ATTACHMENT 1 TO AEP:NRC:1202

10 CFR 50.92 ANALYSIS FOR CHANGES TO THE

DONALD C. COOK NUCLEAR PLANT UNITS 1 AND 2

TECHNICAL SPECIFICATIONS

FIGURE 5.6-1: Normal Storage Pattern (Mixed Three Zone)

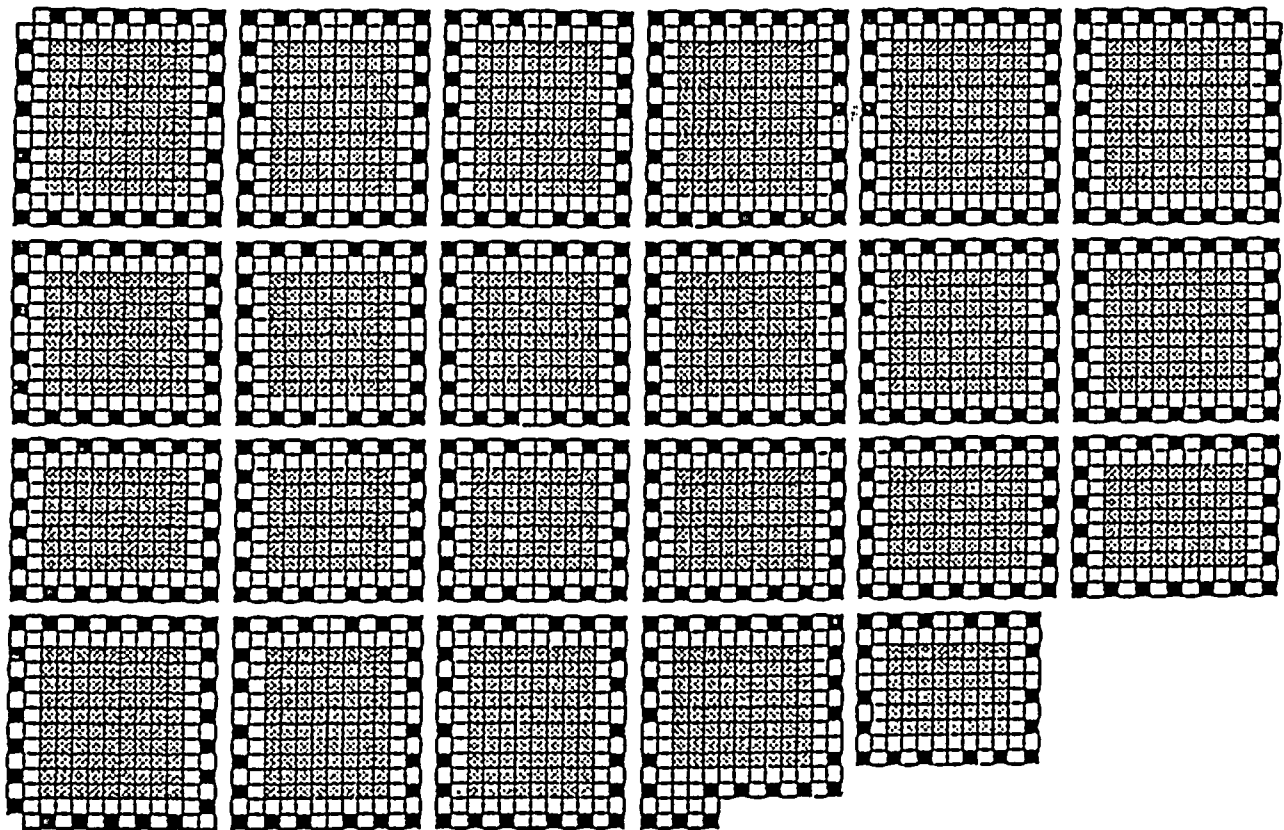
1. We are proposing to change T/S 3.9.3 to allow start of core offload 100 hours after core subcriticality.
2. Changes to Figure 5.6-1 are intended to correctly identify the number of region 1, 2, and 3 cells in the Normal Storage Pattern (Mixed Three Zone).
3. Changes to Figure 5.6-2 are intended to correctly identify the number of region 1, 2 and 3 cells in the Interim Storage Pattern (Checkerboard).

- #1 The amount of time the reactor must be subcritical before movement of irradiated fuel is decreased from 168 hours to 100 hours.
- #2 The number of region 1, 2 and 3 cells in Figure 5.6-1 is correctly changed from 504, 1415, 1694 to 504, 1439, 1670, respectively.
- #3 The number of region 2 and 3 cells in Figure 5.6-2 is correctly changed from 1415 and 1379 to 1439 and 1355, respectively.
- #4 Clarifications are made with respect to our spent nuclear fuel pool storage rack boron poison surveillance program commitments.

1439

1670
